**SUBDIVISION &
ZONING AMENDMENT STAFF REPORT****Date: March 17, 2022****APPLICANT NAME**

Sandalwood Subdivision

Subdivision Approval to create one (1) legal lot of record from an existing metes-and-bounds parcel; and Rezoning from R-1, Single-Family Residential District to B-3, Community Business District.

SITE PLAN

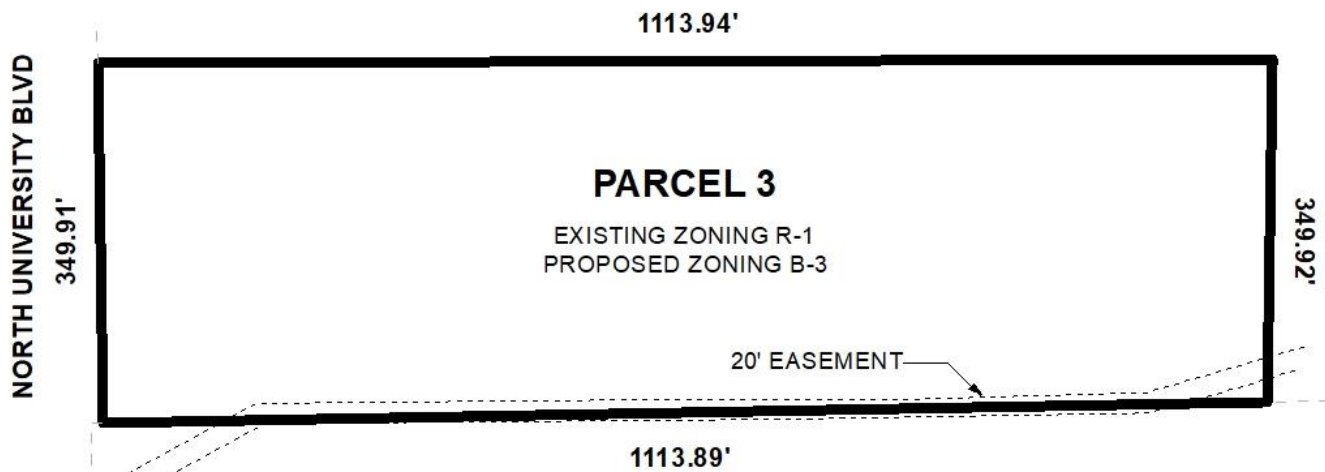
The site has frontage along North University Boulevard, a component of the Major Street Plan, with a planned 100-foot right-of-way width. The preliminary plat does not provide a right-of-way width along North University Boulevard and only indicates a variable right-of-way width. Therefore, the plat should be revised to provide the current right-of-way width along North University Boulevard, and, if less than 50-feet from the centerline to the property frontage, dedication to provide 50-feet from the centerline should be required. The preliminary plat does not indicate a 25-foot minimum building setback line. Therefore, the plat should be revised to indicate a 25-foot minimum building setback line along North University Boulevard, adjusted as to be measured from any required dedication, if approved.

The preliminary plat indicates a sanitary sewer easement along the South boundary of the site. Therefore, a note should be required on the Final Plat stating that no structures shall be constructed or placed within any easement without permission of the easement holder, if approved.

- 2) revision of the plat to provide the current right-of-way width along North University Boulevard, and, if less than 50 feet from the centerline to the property frontage, dedication to provide 50 feet from the centerline is required;

- 3) revision of the plat to indicate a 25-foot minimum building setback line along North University Boulevard, adjusted as to be measured from any required dedication;

- 4) placement of a note on the Final Plat stating that no structures shall be constructed or placed within any easement without permission of the easement holder;
